Thank you for your interest in the Xilinx Spartan™-3AN family XC3S50AN FPGA device engineering samples. Although Xilinx has made every effort to ensure the highest possible quality, these devices are subject to the limitations described in this errata notification. These errata do not apply to the XC3S50AN production FPGAs.

Table 2: Hardware Errata Summary

Figure 2: XC3S50AN ES Package Dimensions with Exposed Pad

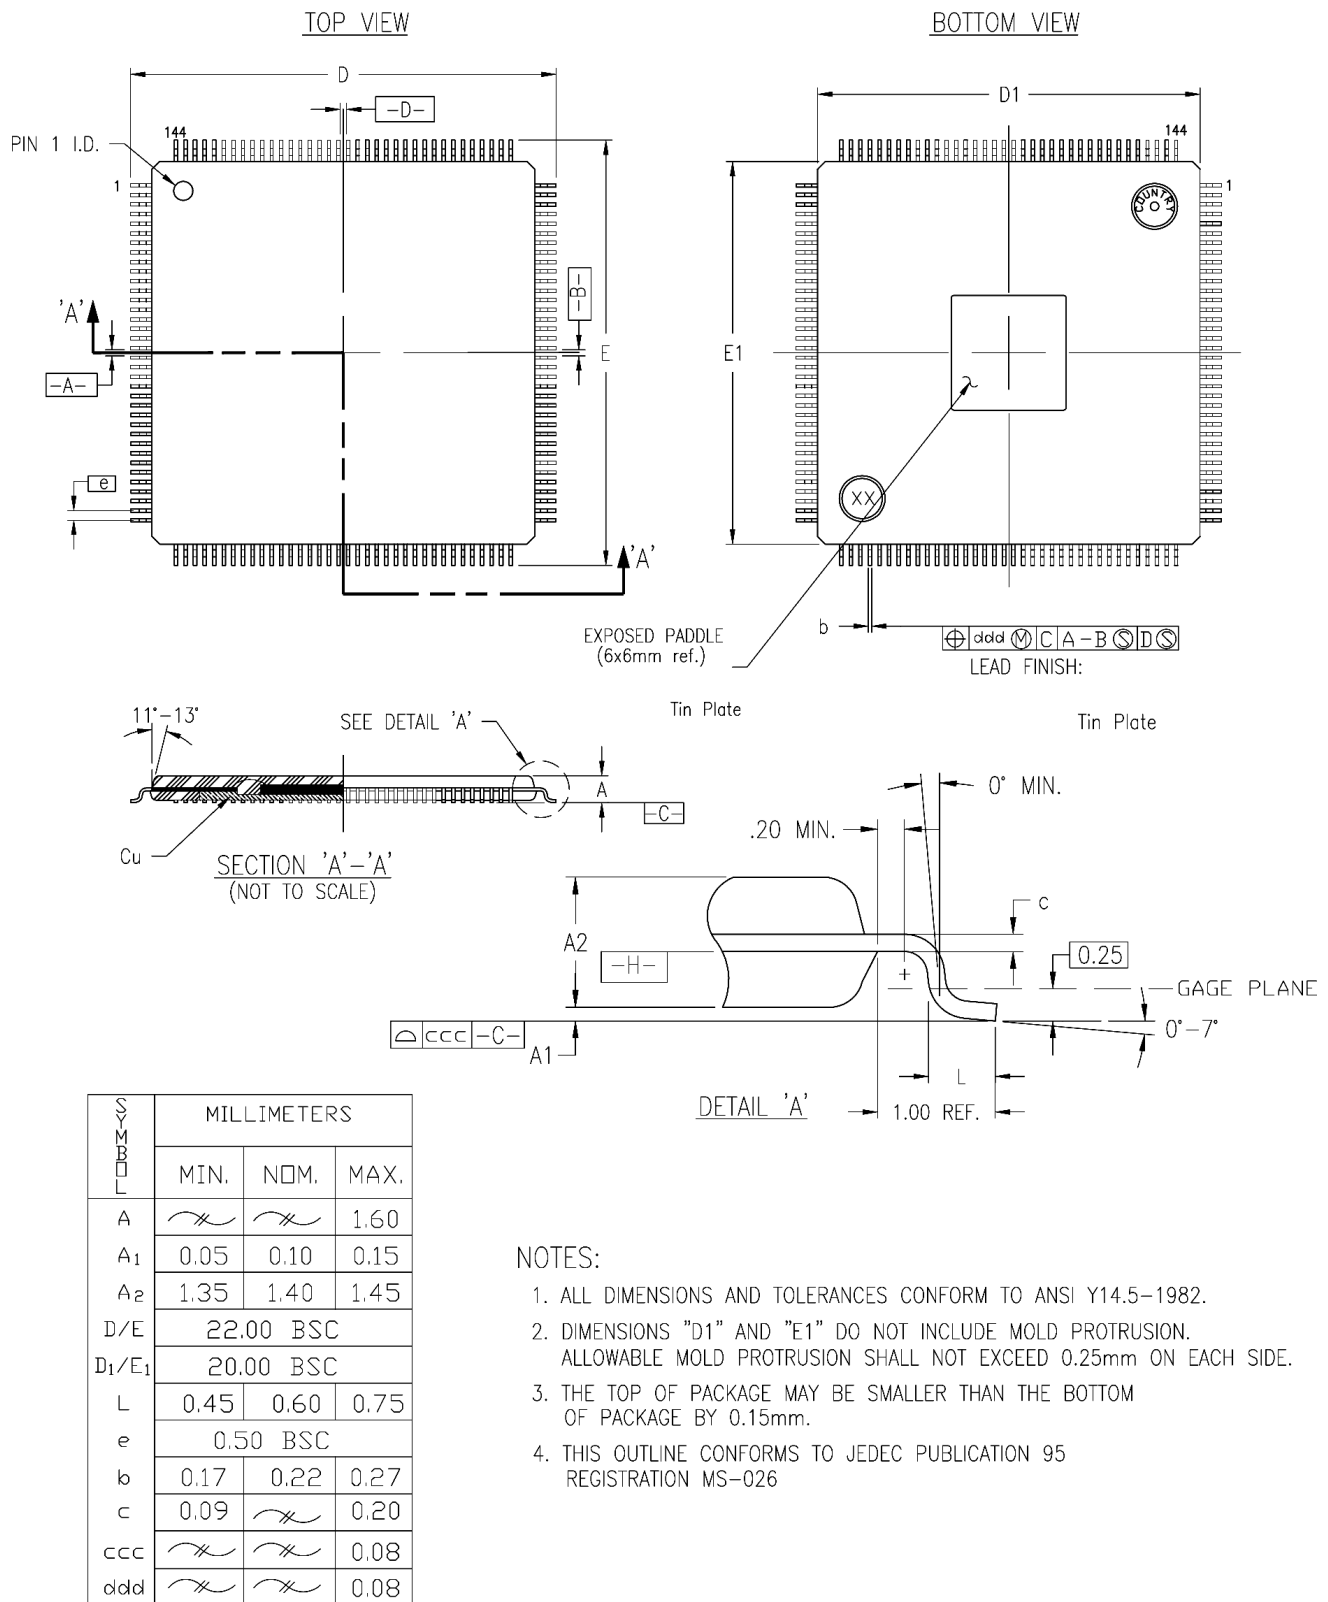
The XC3S50AN FPGA engineering samples are offered in only one package and therefore this issue could affect all applications. This issue specifically restricts applications that route signals under the package.

The XC3S50AN engineering samples are assembled in a non-standard package with an exposed metal pad on the bottom. The package dimensions shown in [Figure 2](#) match those of the standard TQG144 package which will be used for production. As shown in [Figure 2](#), the package used for the engineering samples has an exposed pad in the middle of the bottom side, with maximum dimensions of 6mm x 6mm. The exposed pad package is typically used to enhance thermal characteristics and signal integrity, but is not being used for those reasons. The package is only a temporary solution until the production package is available. All thermal, material, and reliability characteristics of this package are similar to those of the standard package.

Do not route signals in the area of the exposed pad. The exposed pad can be unconnected on the board, or it can be connected to GND. Do not use the engineering samples for qualification.

This issue has been corrected in production revisions of the XC3S50AN device. Production devices use the standard TQG144 package, with a different assembly process and without the exposed pad.
